**EB-2025-0064 Enbridge Rebasing Application – Phase 3  
Pollution Probe Interrogatories**

**Enbridge Gas Inc.  
Rebasing Phase 3**

**POLLUTION PROBE INTERROGATORIES**

Figure 1 – IRP Screening and Evaluation Process

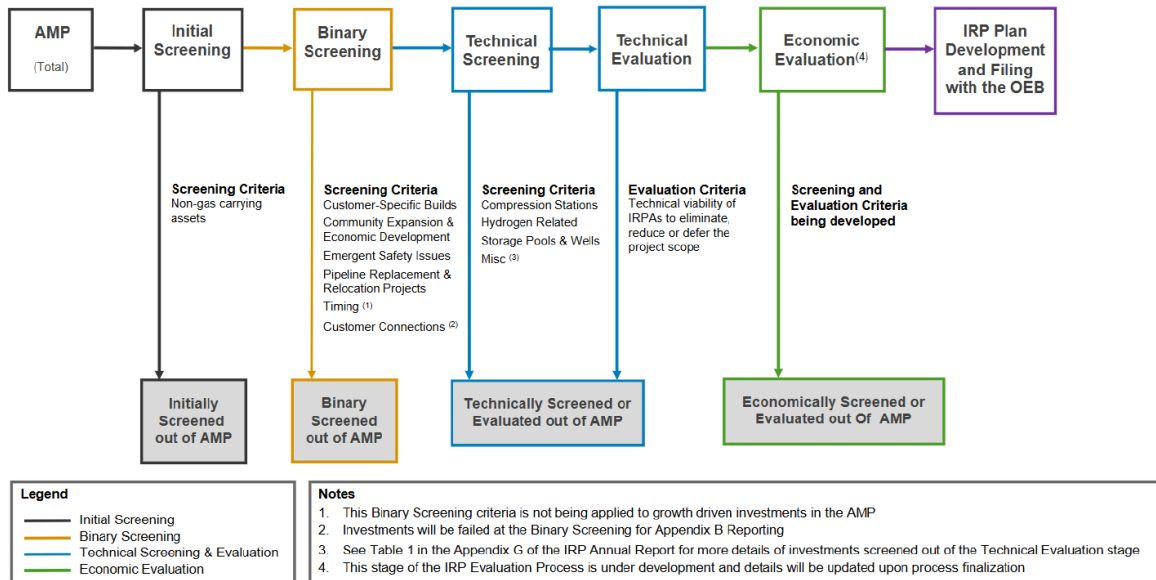
- For each of the seven screening steps noted above and the four resulting categories at the bottom of the diagram, please provide an updated version including the number of projects that relate to each box, based on the most current AMP.
- For each of the seven screening steps noted above, please indicate how many FTE's from each department conduct each step.
- For each of the seven screening steps noted above, please indicate which Enbridge positions are responsible for the review and approval of recommendations for what projects make it to the next step or are screened out.
